Dear Reviewer:

Reviewer 1

Fig. 1. Relationship between impact velocity and impact force

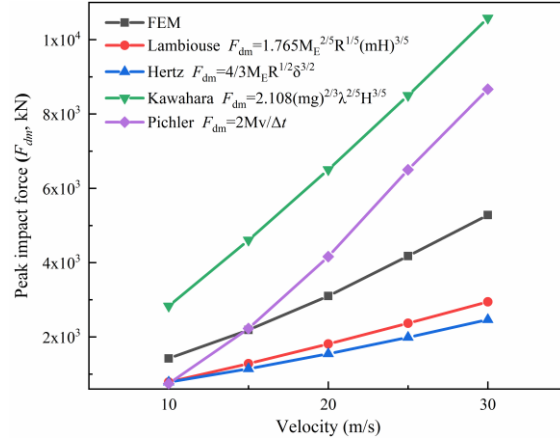
4. General Comments:

The discussion section of this manuscript is relatively weak. It is recommended that the author, based on reading and referring to a large number of literature, describe the advantages and limitations of the data, models, methods, results, etc. involved in this manuscript.

A comparative analysis was performed to evaluate the validity of the calculations in this manuscript, comparing the elastic theories proposed by (Labiouse et al., 1996), Kawahara and Muro (2006), Pichler et al. (2006), and Hertz (1997) with the computational results obtained in this study (Fig. 1). The findings reveal a fundamental linear correlation between impact force and velocity. In general, the computational results in this manuscript align with those of other models of similar magnitude, thereby validating the calculations presented herein.
